NZ 63/04 PAPUA NEW GUINEA -- Brumer Island to Uluma Reef -- Shoals Disproved.

Chart NZ 14060 (INT 60) [62/04]

Chart NZ 14604 (INT 604) [50/04]

LAST CORRECTION	NZ NTM No.	CHART No.
NZ 62/04	NZ 63/04	NZ 14060 (INT 60)

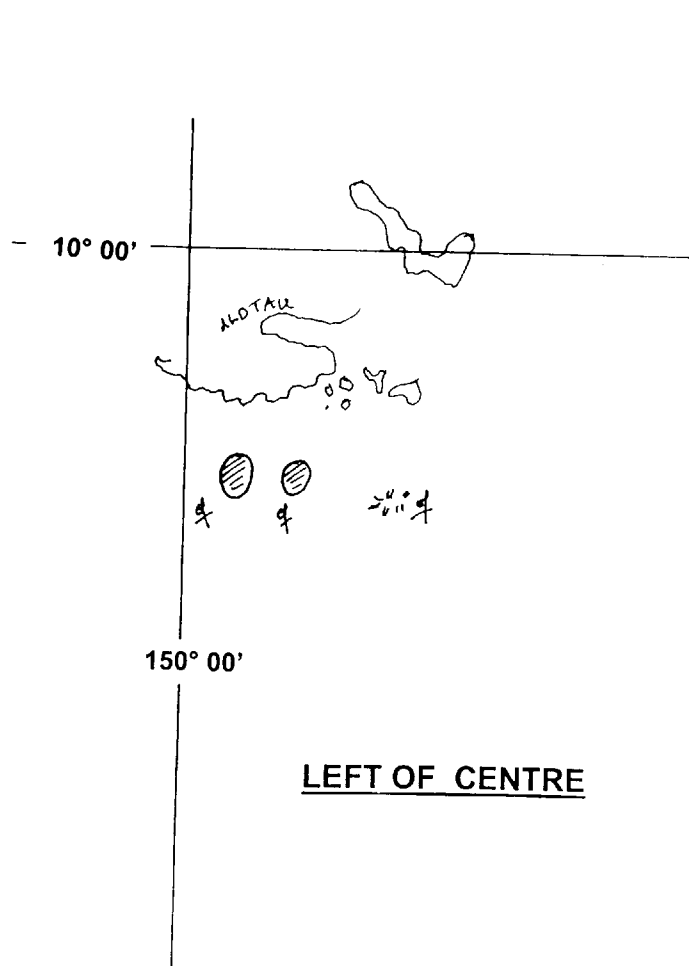
Delete depth 115m and enclosing contour 11° 00'.0 S 150° 15'.0 E

LAST CORRECTION	NZ NTM No.	CHART No.
NZ 50/04	NZ 63/04	NZ 14604 (INT 604)

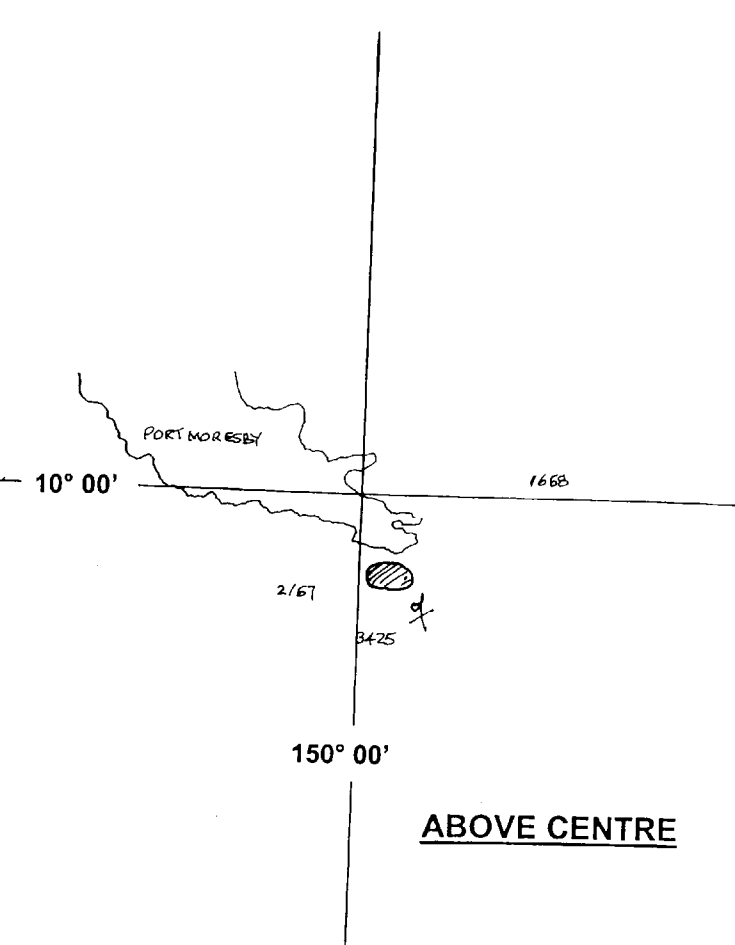
Delete depth 115m and enclosing contour 11° 00'.4 S 150° 14'.8 E
 Delete depth 110m and enclosing contour 11° 00'.4 S 150° 29'.5 E
 Delete 30m contour centred on 11° 07'.5 S 150° 55'.5 E
